RE: TEDS Exception to Reduce Parking Lot Access Spacing at 1100 Independent

DESIGN EXCEPTION #DE02-03

RE: Request to Reduce Parking Lot Access Spacing at 1100 Independent

RE: Traffic Engineering Design Standards (TEDS) Exception
Section 4.1.1, Spacing
Golden Corral Parking Lot (In CDOT ROW)

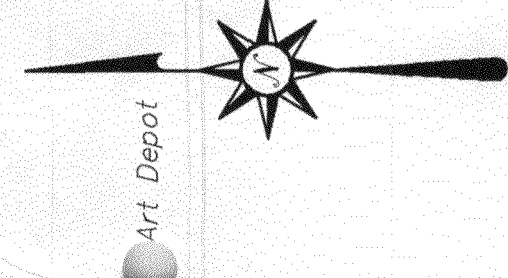
In order to meet the stipulations outlined above in Existing Conditions, it is necessary to provide access to the proposed parking lot from Bogart Lane, approximately 50' (centerline to centerline) south of the approved access to the existing Golden Corral parking lot (see attached site plan). This is less than the 150' separation proscribed in Section 4.1.1 of the TEDS Manual.

I recommend approval of the requested Design Exceptions to Section 4.1.1 to allow the two parking lot accesses onto Bogart Lane, as requested at this location.
